RESOLUTION HOLDING HEARING ON REQUEST FROM ELECTRO MANAGEMENT CORPORATION (OWNER) FOR REVIEW AND APPROVAL OF A PUD FINAL DEVELOPMENT PLAN AMENDMENT, "CITY GATEWAY-PHASE 1A", FOR PROPERTY LOCATED AT 4240 ARMY POST ROAD TO ALLOW EXPANSION FOR THE EXISTING WAREHOUSE WITH A 60,000 SQUARE FOOT BUILDING ADDITION AND ON-SITE SURFACE PARKING EXPANSION

Communication from the City Plan and Zoning Commission advising that at their July 16, 2020 meeting, the following action was taken regarding a request from Electro Management Corp. (owner) represented by Britt Baker (officer) for review and approval of an PUD Final Development Plan amendment "City Gateway – Phase 1A", for property located at 4240 Army Post Road, to allow expansion of the existing 242,800-square foot Workshop/Warehouse Building with a 60,000-square foot addition and on-site surface parking expansion.

STAFF REPORT TO THE PLANNING COMMISSION

SITE PLAN CITY GATEWAY DES MOINES, IOWA

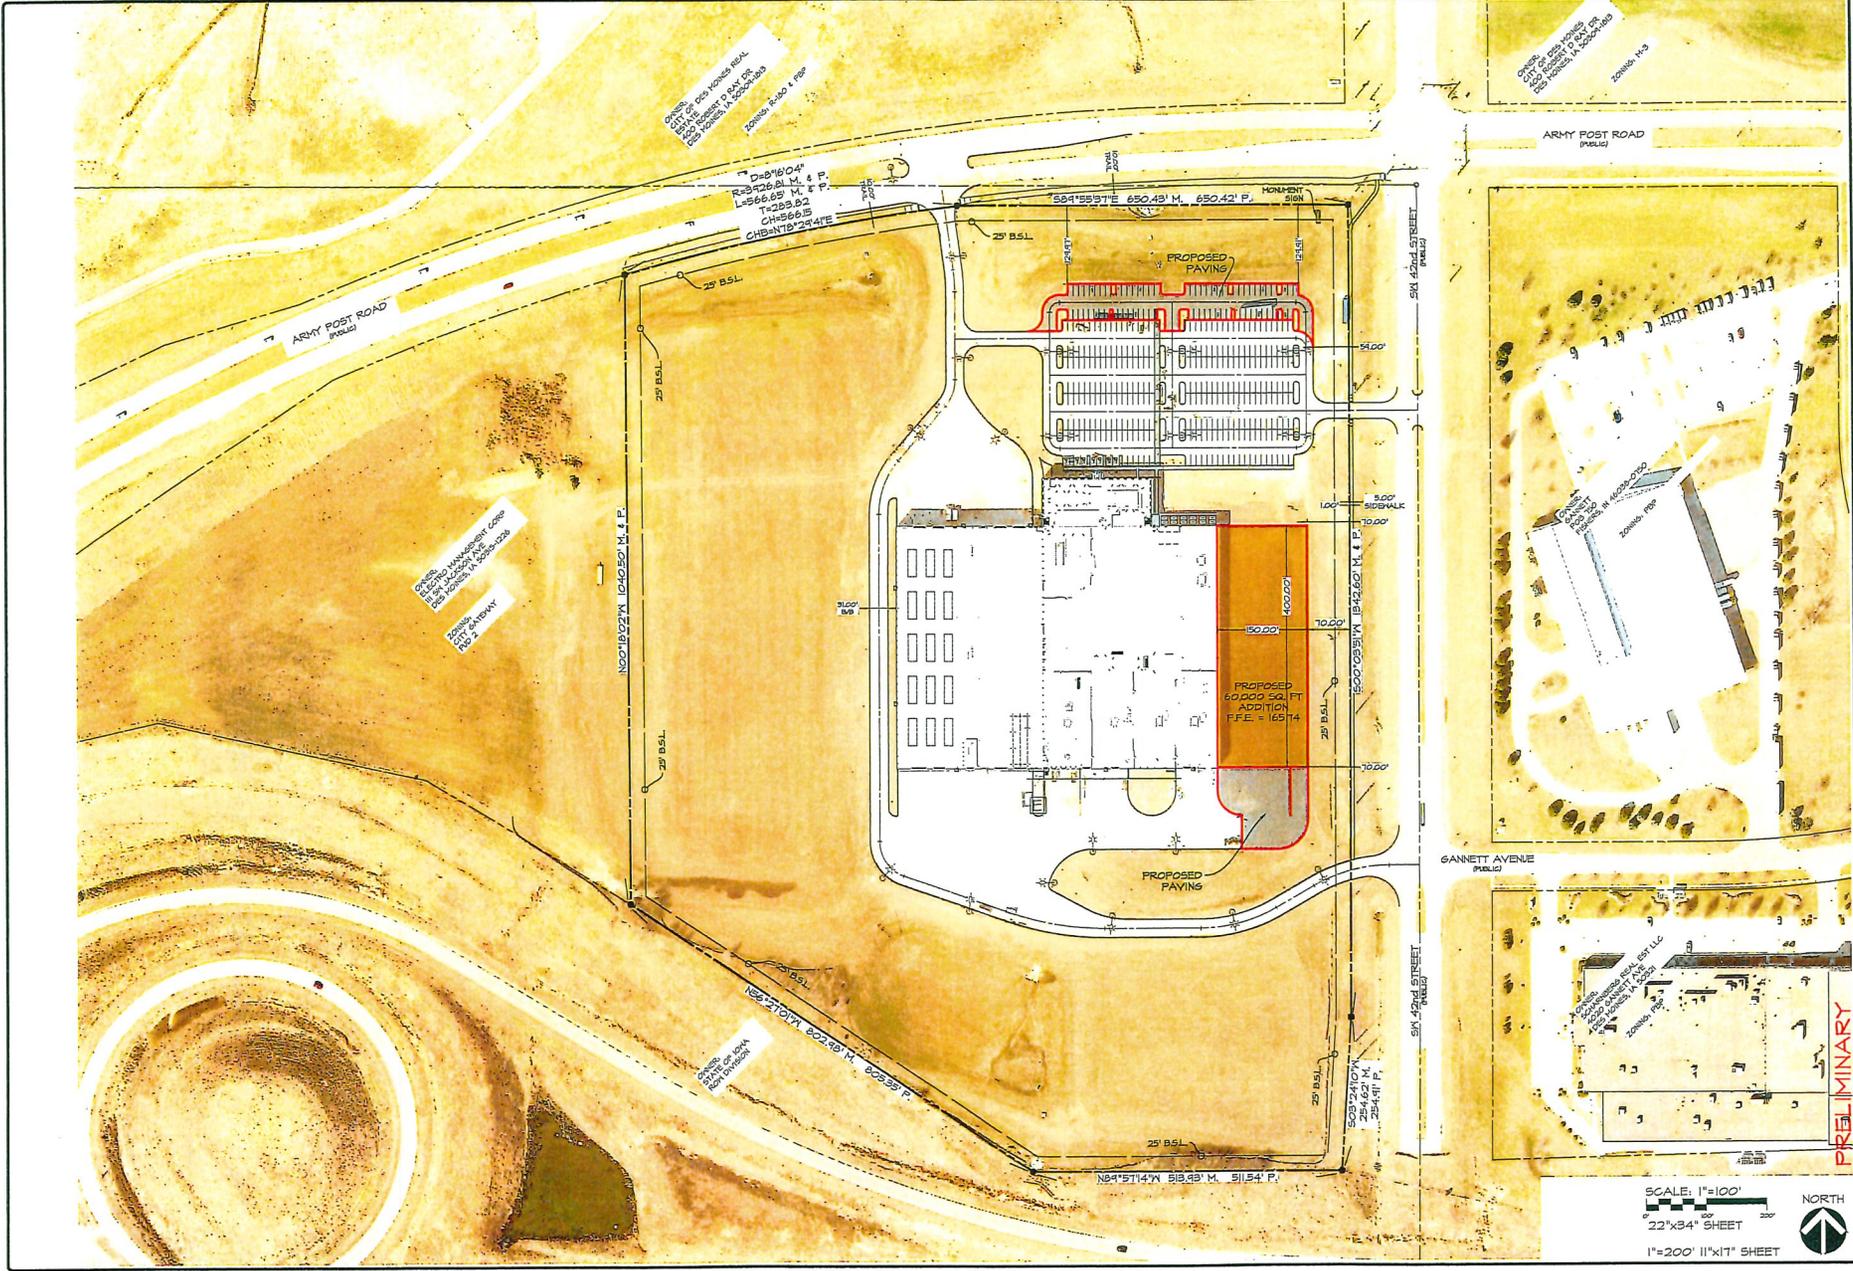
After review of the submitted PUD Final Development Plan the only Staff concern is regarding the screening of rooftop mechanical equipment. The submitted plan indicates that the equipment shall be screened from street level view and from adjoining residential areas. The requirement for new construction is that such equipment be screened on all sides to the height of the equipment if it is over 3 feet in height with architectural methods such as a parapet of the building or a metal screening system. Staff believes that the PUD Final Development Plan should be updated to reflect this standard in Chapter 135 of the City Code.

1. Compliance with all administrative review comments by the Permit and Development Center.
2. Revision of the requirement for rooftop mechanical units to indicate that all rooftop mechanical units be screened in accordance with Chapter 135 Section 135-4.4.5 of the City Code.
